Access Compliance Report

# Public Rights-of-Way
(Curb Ramps)

Intersection ID: 32307	**Main Street: BRIDGEVIEW_LN**	**Cross Street: NEW_PROVIDENCE_LN**	**Location:**	**SE**
ADA ID: D62485A5D91A	**Ramp Type: PerpDiag**	**Initial Pass/Fail: Fail**	**Overall Compliance: No**	**Severity Score: 25**

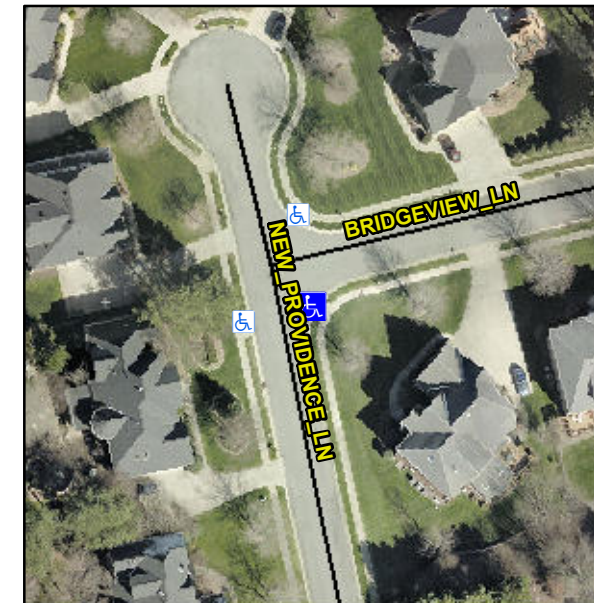
Not Found, R304.5.3

Compliance	Description	Data	Compliance	Description	Data
N/A	Ramp Length (in)	47.0	Yes	Ramp Slope (%)	5.9
Yes	Ramp Width (in)	48.0	No	Ramp XSlope (%)	9.4
N/A	Flare Type LT	N/A	N/A	Flare Type RT	N/A
N/A	Flare Slope LT (%)	N/A	N/A	Flare Slope RT (%)	N/A
N/A	Flare Traversable LT?	N/A	N/A	Flare Traversable RT?	N/A
N/A	Landing Length (in)	N/A	N/A	DWS Provided?	N/A
N/A	Landing Width (in)	N/A	N/A	DWS Contrast?	N/A
N/A	Landing Slope (%)	N/A	N/A	DWS Length (in)	N/A
N/A	Landing X Slope (%)	N/A	N/A	DWS Full Width?	N/A
N/A	Landing Curb? (Y/N)	N/A	N/A	DWS Offset (in)	N/A
N/A	Shared Landing?	N/A			
N/A	Gutter Ponding?	N/A	N/A	Gutter Slope (%)	N/A
N/A	Gutter Lip Ht (in)	N/A	N/A	Gutter X Slope (%)	N/A
N/A	Painted X Walk1?	No	N/A	Painted X Walk2?	No
	X Walk 1 Direction	To N		X Walk 2 Direction	To W
N/A	X Walk 1 Width (in)	N/A	N/A	X Walk 2 Width (in)	N/A
	X Walk 1 Slope (%)	1.8		X Walk 2 Slope (%)	5.9
	X Walk 1 X Slope (%)	5.8		X Walk 2 X Slope (%)	4.9

Remove & Replace Curb Ramp With Two New Directional Ramps or Equivalent.
